From: [Aldo Tarigo](#)
To: [Taylor, Tammy](#)
Subject: 21 Barranca documents
Date: Tuesday, September 04, 2018 3:46:50 PM
Attachments: [180903 Discrepancies between 21 Barranca Rd Project Documents and Initial Study Interpretation.pdf](#)

Discrepancies between 21 Barranca Rd Project Documents and Initial Study Interpretation

Tarigo/Terrass Project Areas

21 BARRANCA RD - EXISTING SITE IMPERVIOUS

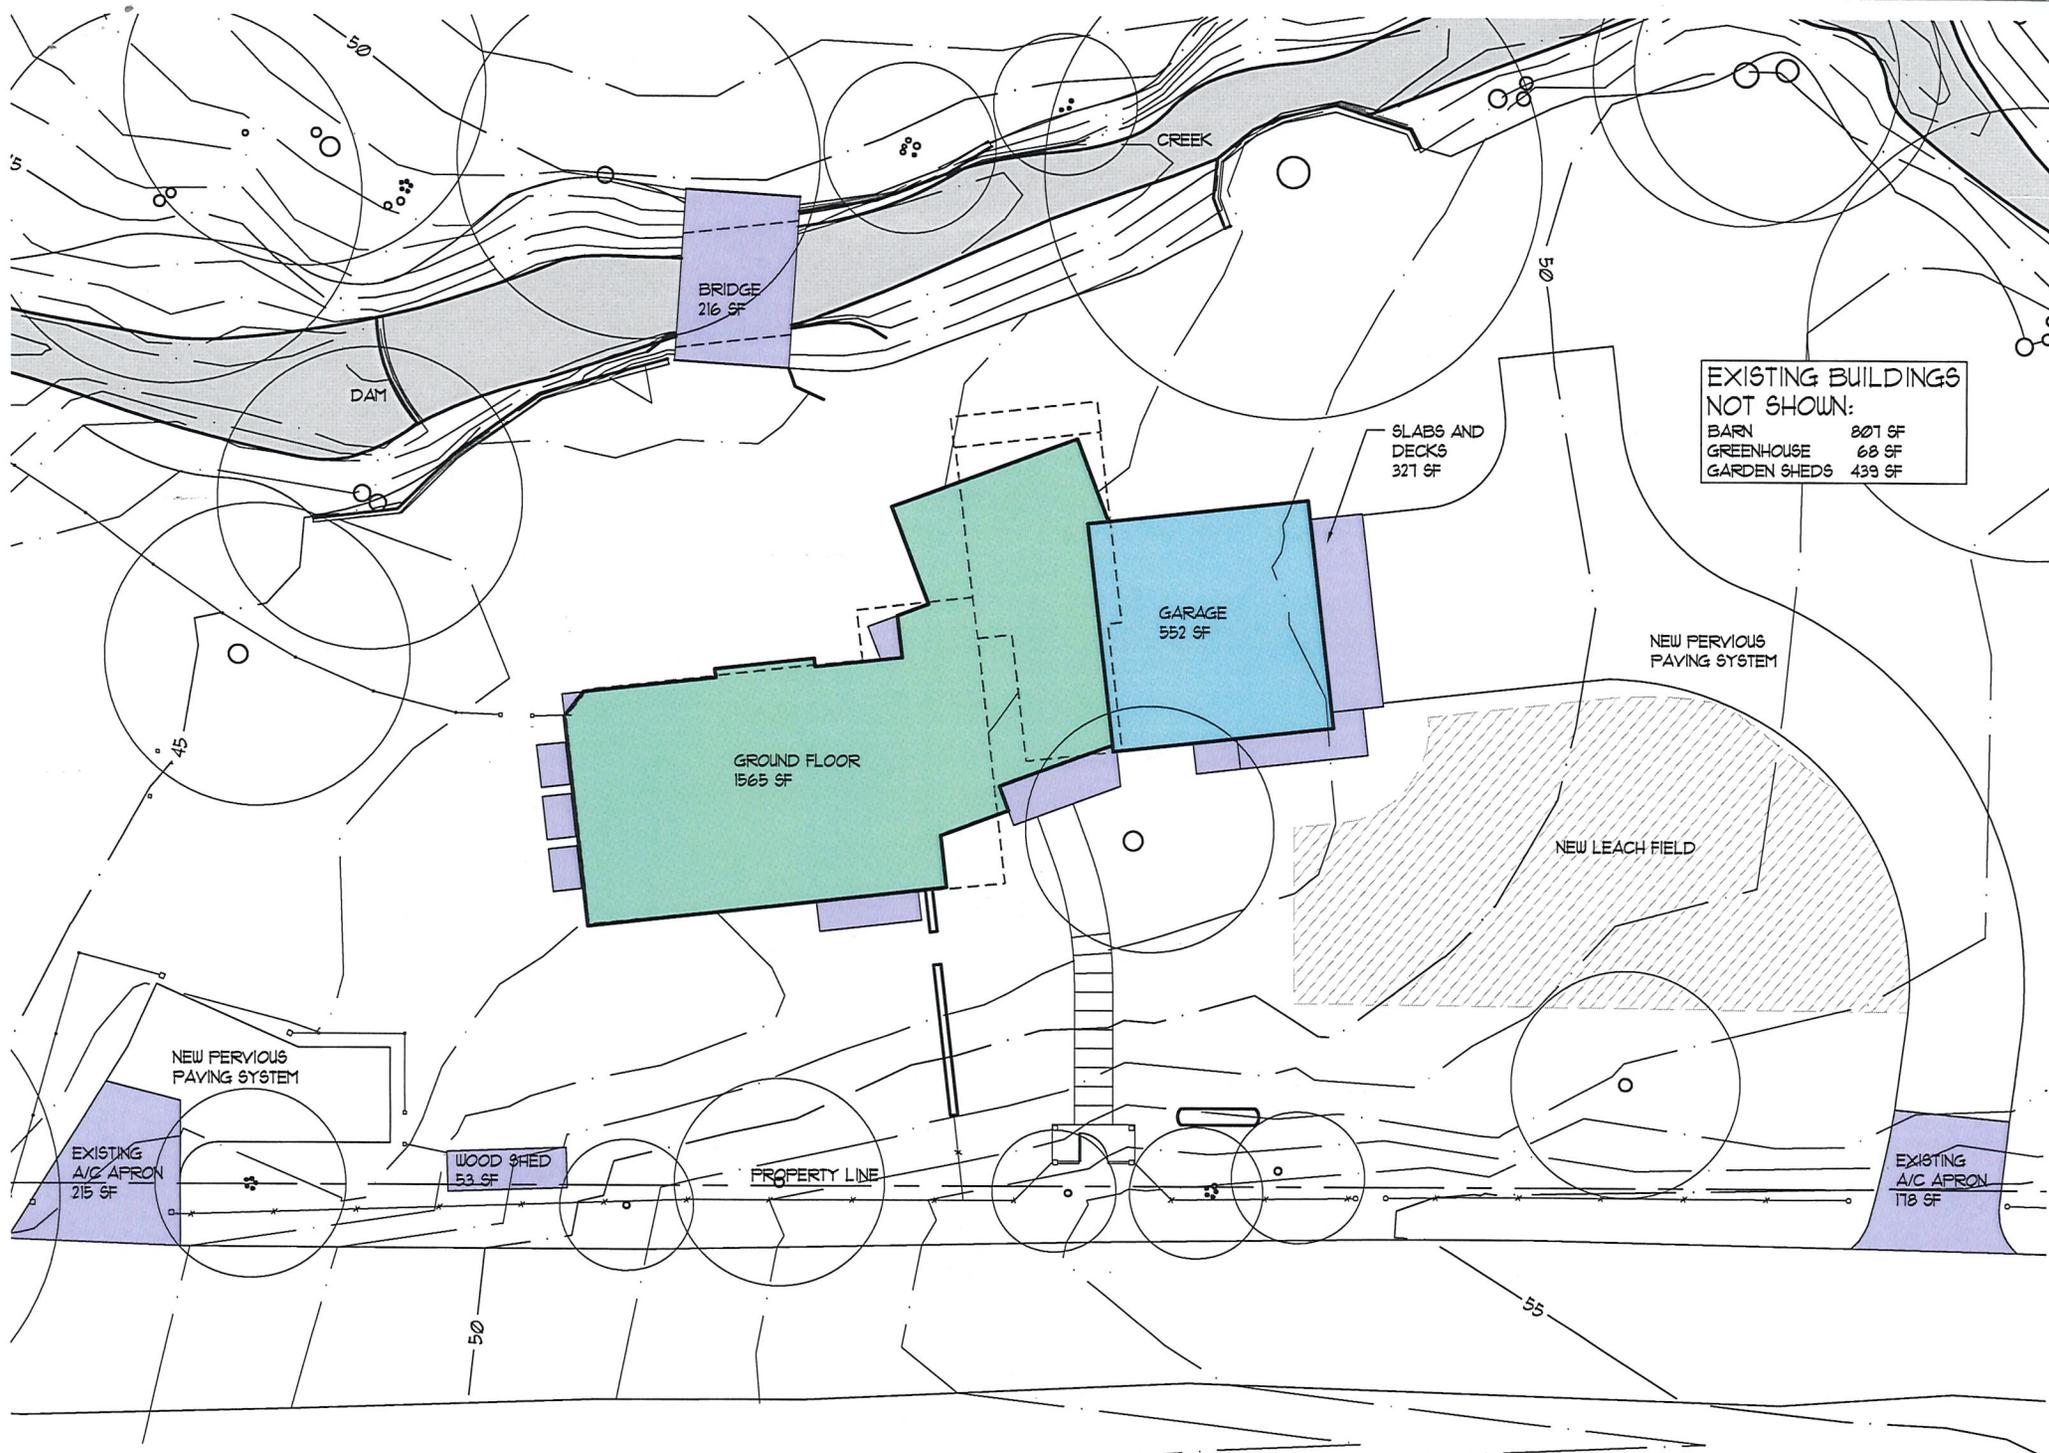
- Lot Coverage, both existing and proposed, are miscalculated in the Initial Study, indicating an increase in Total Impervious Area of 84% for the proposed project. It actually proposes a net decrease of TIA by 28%. This error originated due to the following incorrect data:

- The proposal specifies TuffTrack, a pervious paving system, for the new driveway, but it is treated as impervious in the analysis, while a product with inferior specifications for permeability is recommended as a mitigation. Proposed Lot Coverage is mistakenly inflated some 2000sf by the inclusion of this pervious area.

- From the outset the project has proposed the restoration of 2300sf of semi-pervious compacted road base to ecologically functional habitat, as described in the text of the Initial Study. However, this area is omitted from the total for existing Lot Coverage, and its conversion to permeability is not shown to have lowered TIA as proposed. Marin County Code specifies that any surface with runoff of more than 50% shall be included in Lot Coverage. It is unclear why it was not included after our project was assigned to a second planner due to a change of personnel, and this omission was only revealed to us in the IS. Upon identifying such a dramatic addition to Lot Coverage, Planning should have verified the figure or warned us that if it was correct, the project would be in violation of the County Wide Plan. Furthermore, when we pointed out this error, among others, we were denied any route to correcting the data other than the current appeal.

Figure 3-7. Flood frequency curve for the San Geronimo Creek at Lagunitas Road bridge (WY 1980-2006).

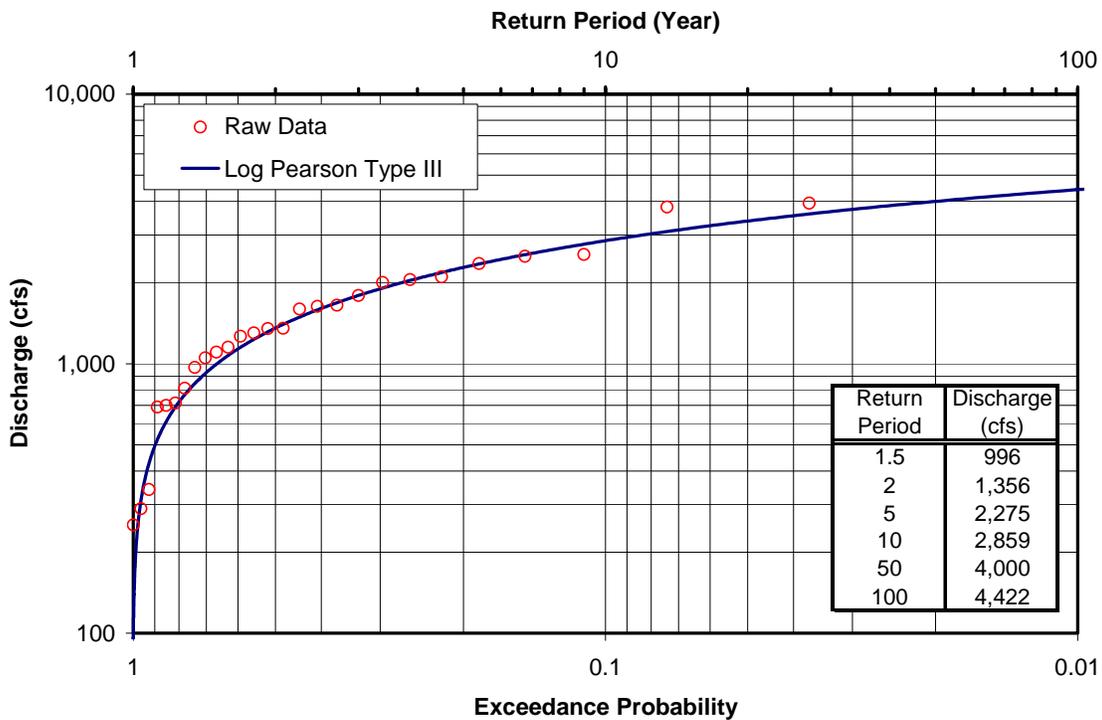
- The Existing Conditions section of the San Geronimo Valley 2009 Salmon Enhancement Plan makes use of 26 years of actual gaged data to project the 100-yr peak flood elevation of San Geronimo creek at Lagunitas Bridge. Since Barranca creek is a tributary of San Geronimo creek, this data was used to extrapolate the 100-year peak water elevation at the bridge at 21 Barranca Rd, which when modeled substantiates a freeboard of 29" from water surface elevation (WSE) to bottom of the span. The other method, the USGS's "Methods for Determining Magnitude and Frequency of Floods in California, Based on Data through Water Year 2006", published in 2012, results in an even lower WSE, yielding an even greater freeboard measurement. In comparison, the County-preferred TR-55 method overestimates peak flow by as much as 46% as compared with the published SGV SEP data, thereby reducing apparent freeboard to less than the 24" required by code. Flow transference methods, as used in the SGV SEP and our hydrology report, are preferred by California Department of Forestry and Fire Protection (Cal Fire) for determining 100-year flood flows, providing much more accurate data than regional regression modeling such as TR-55. Cal Fire further recommends that the TR-55 result should be calibrated to local measured data wherever such data exists. Doing so by using the lower end of the 90% confidence level, the bridge does then meet the 24" required minimum freeboard.
